Reason: Installation of larger buffer plates for the rubber buffer of landing gear.

LTA Nr. 68/110

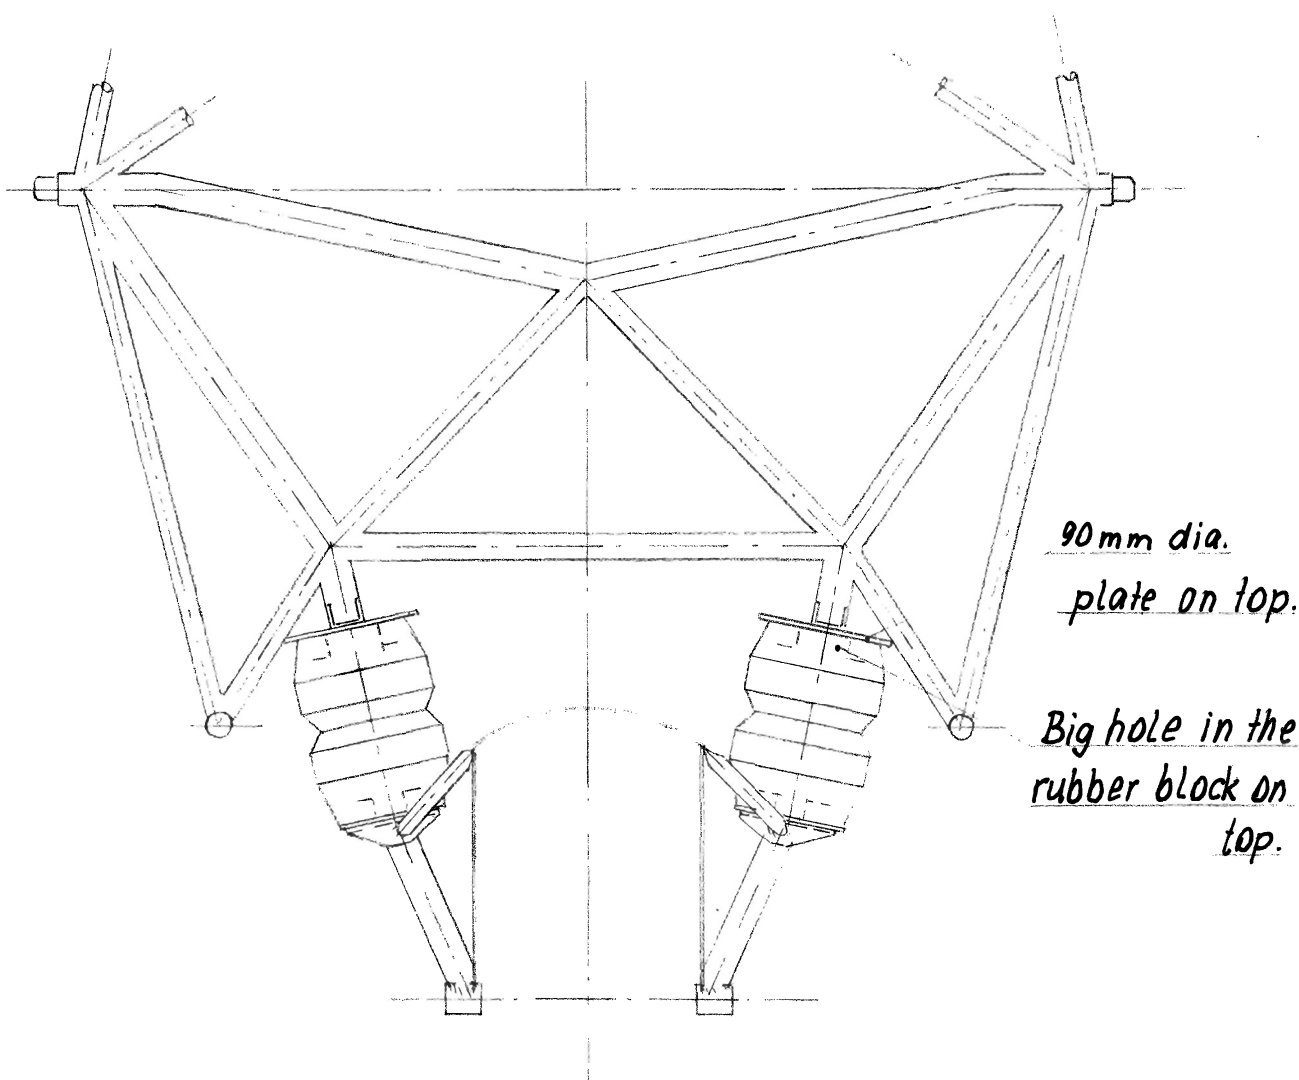
On one occasion the 70 mm dia. buffer plate slipped into the rubber buffer end with the big hole.

Description: Remove the rubber block and replace the buffer plate at the end with the large hole by a plate of 90 mm dia. This new plate is to be installed on top of the rubber block.

Drawings to be corrected	Remarks	LBA - Approved
L-267.10-S 7 and S 11 to be corrected.	4.9.68  Modification is made by the manufacturer at S.Nb. 13071, 13096 and since 13105 without 13108 and 13109.	German original signed: Friess 16.9.1968
